PROJECT DETAILS – TELL US ABOUT YOUR PROJECT

PRINCIPAL FACADE

ARCHITECTURAL SURVEY	
VERSION 1	01
3747 Tyler Detroit	
PRINT A2 (16,5 x 23,375)	
DATE:

PRINCIPAL FACADE

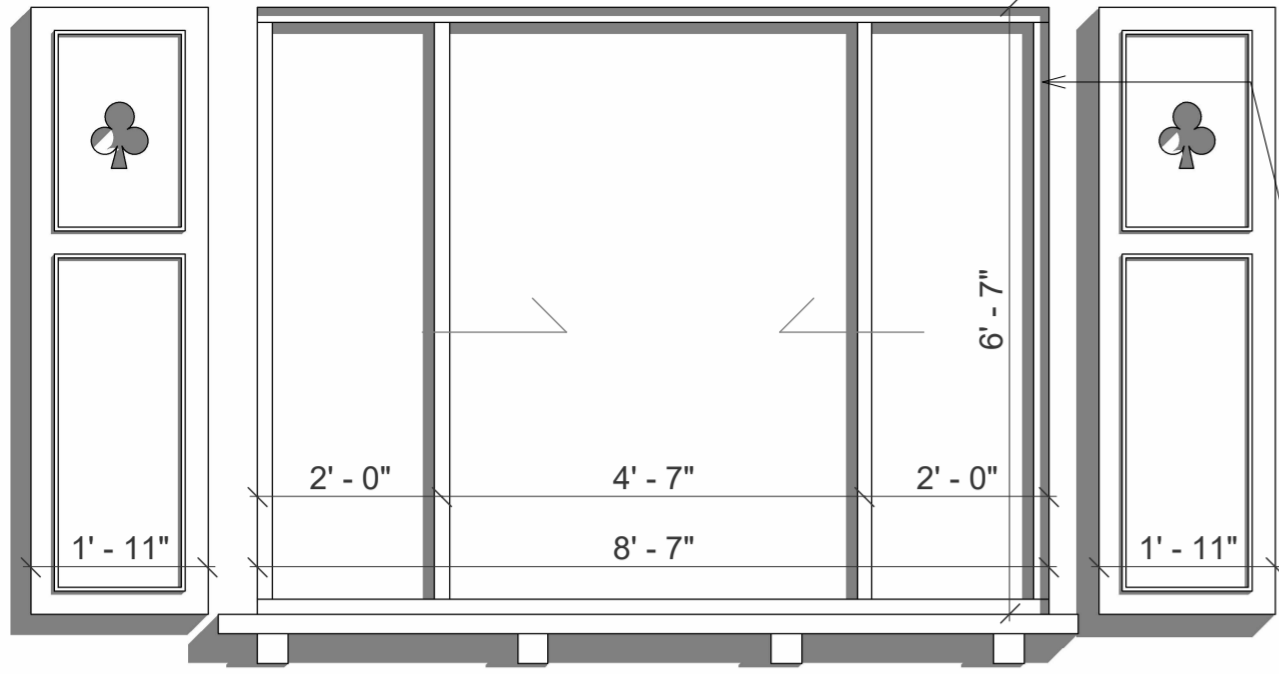
We did change this window in this way because we saw some examples for neighbors that use the same system and design, we want to preserve it but if it's impossible, according to the last report we propose to change it as similar as the original as possible.

5 single hung window using aluminum-clad wood windows frames and paint them in yellowish white color as is specified in the color system E and the stucco in Brownish Pink without changing the original size or shapes.

ACTUAL WINDOW

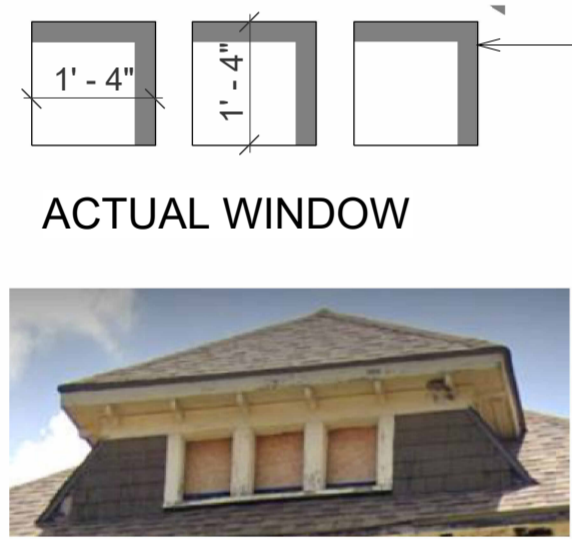
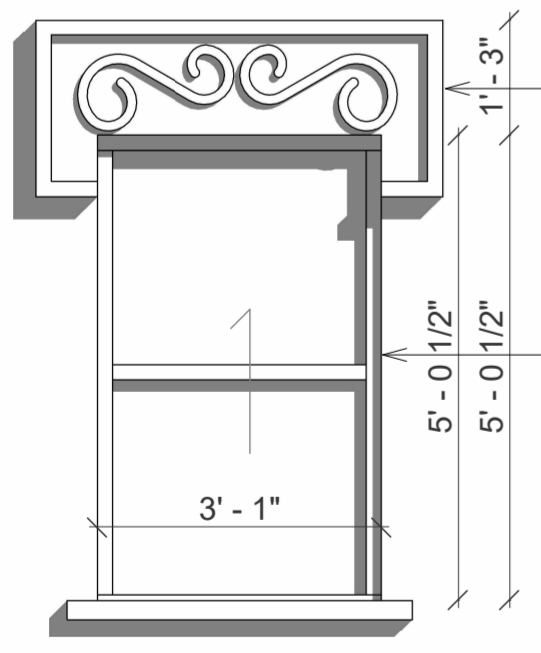
In this moment we don't have those windows in the place, they weren't in good conditions, so we removed and it was covered with a plywood, but we propose to make a new one as similar as the original using aluminum-clad wood windows and painting the frames in yellowish white color. we will not change the original size.

ACTUAL WINDOW

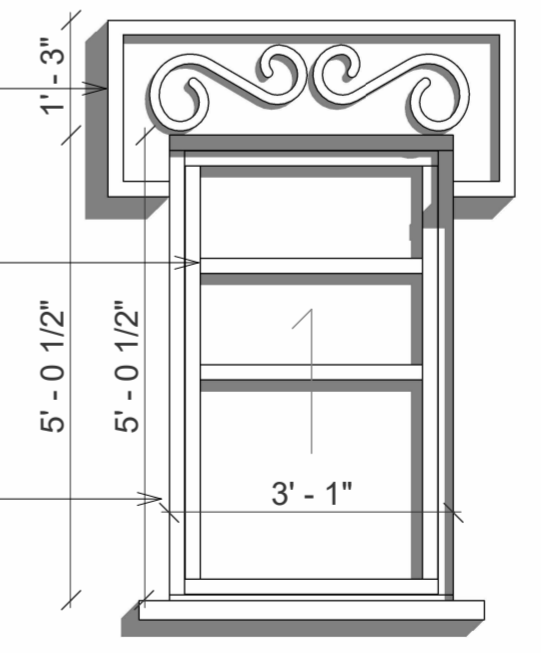
Conserve the same design but paint again with original color

we want to use a faux aluminium-clad wood frame over the window to simulate the original

We understand that all the windows were change by vinyl material but we purpose to unify the color of the single hung window with the original and also put a doble extra frame on it to simulate old ones and boxed it, giving them the same aspect as the original with aluminum-clad wood material

The color for the frames will be selected as the color system E shingles or stucco and half-timbering in different colors.
Wood (C:4 Yellowish White MS: 5Y 9/1)
Stucco (D:1 Brownish Pink MS: 7.5YR 7/2)

SECOND FLOOR DOOR ACTUAL

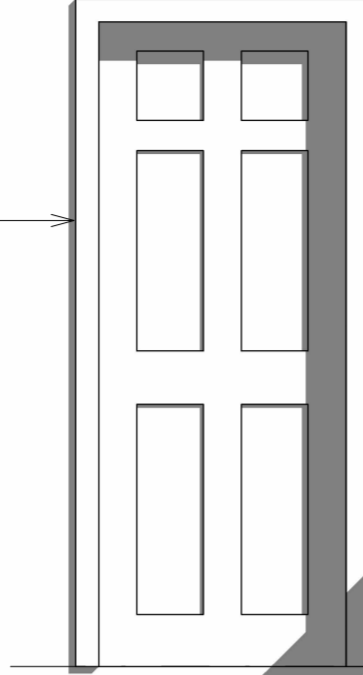
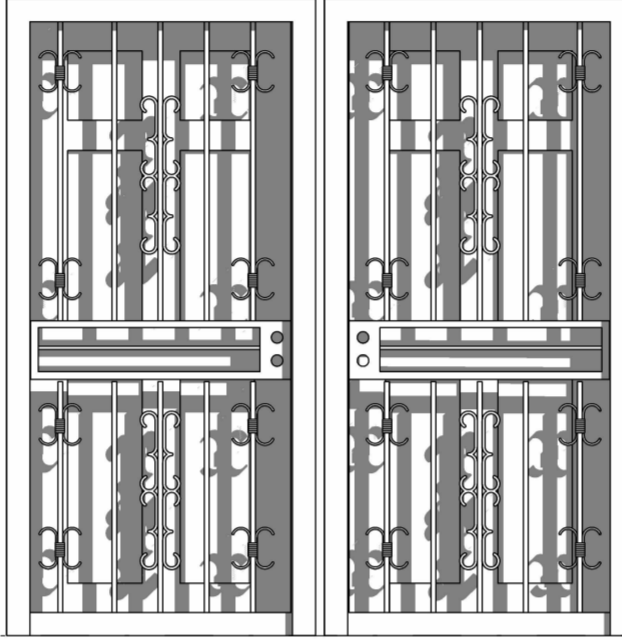
All three doors will be replaced for a single white wood door as original and the gate of the access door will be painted white just like some of the neighbors since it gives a lot of lighting to the facade.

FRONT PORCH

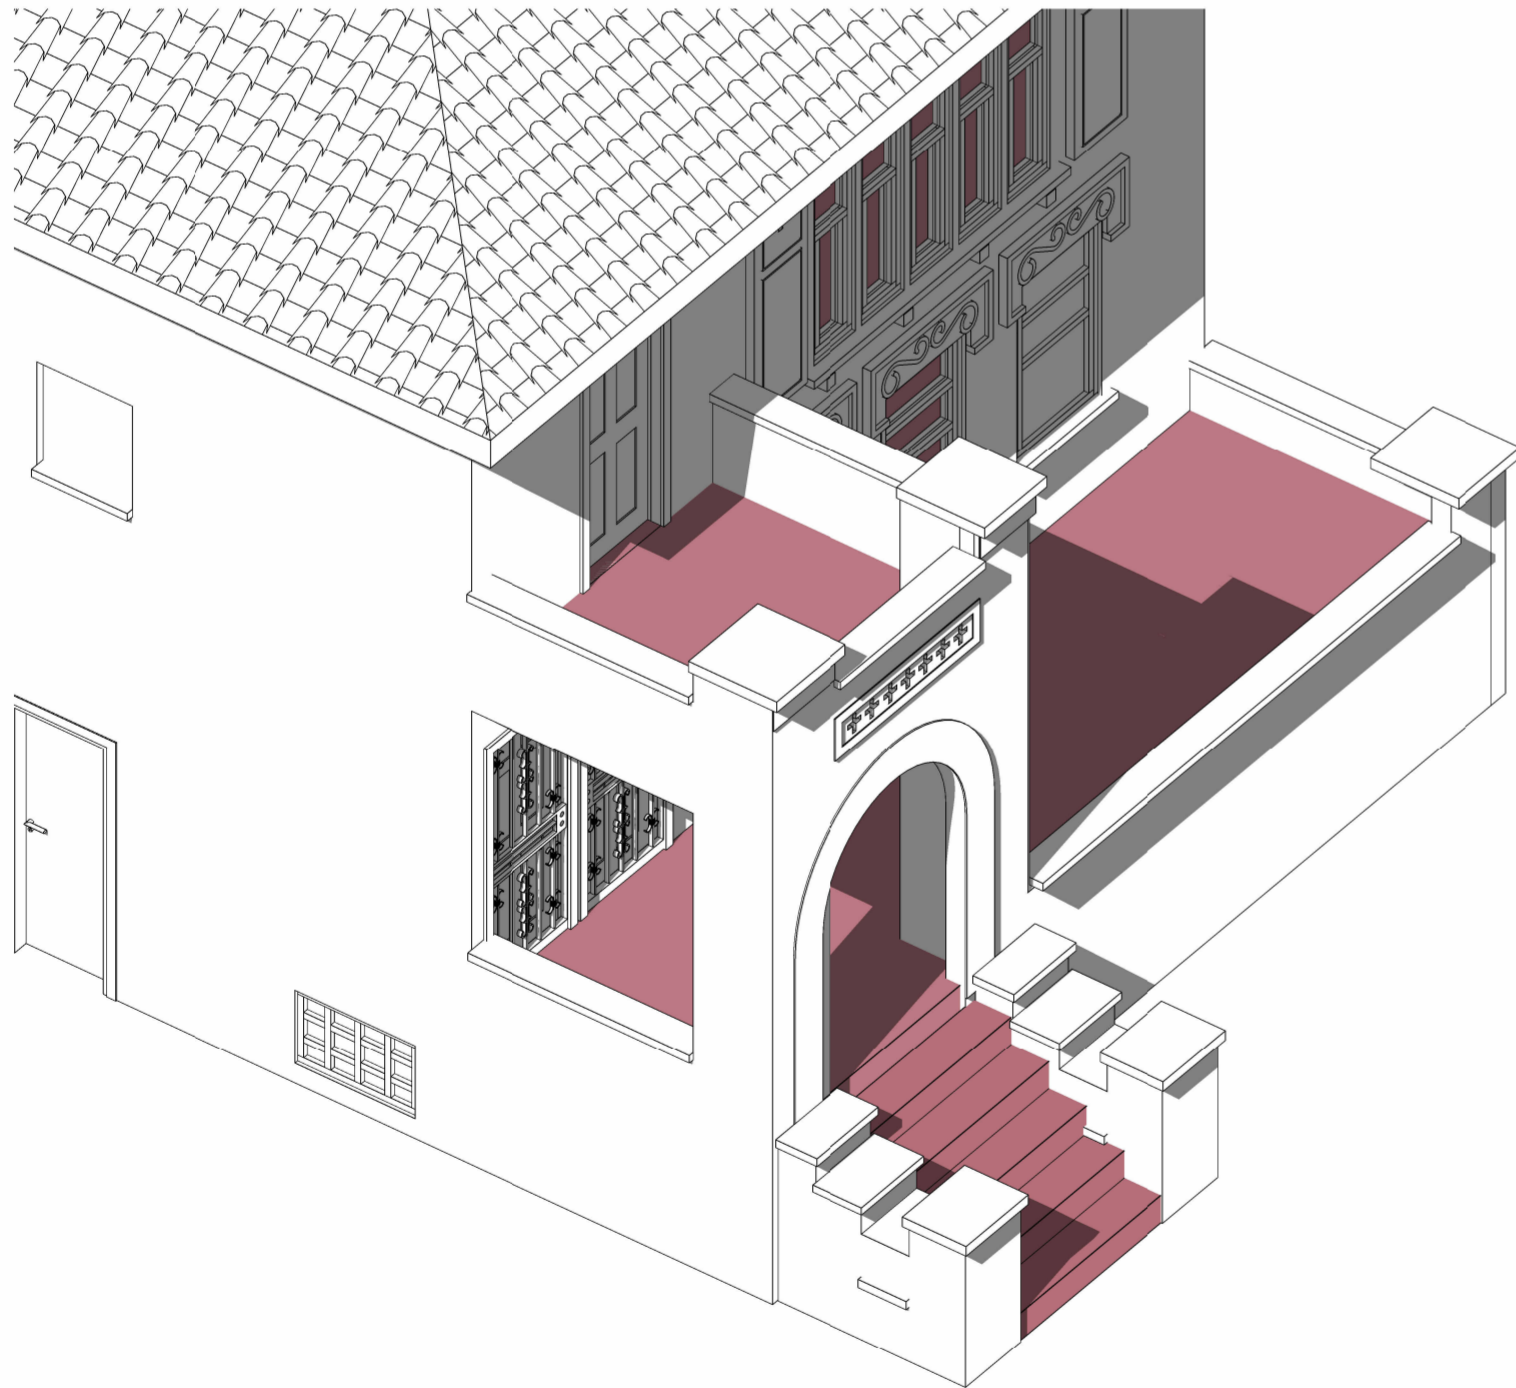
On the front porch we found the materials and floor in poor condition and the stairs are dangerous for traffic, as is the second floor. Needs a complete restructuring and reinforcement to enable it. We are going to clean structures using the gentlest means possible and trying to use the same materials already have there. Also we are going to take out the structure of the extra roof in second flat.
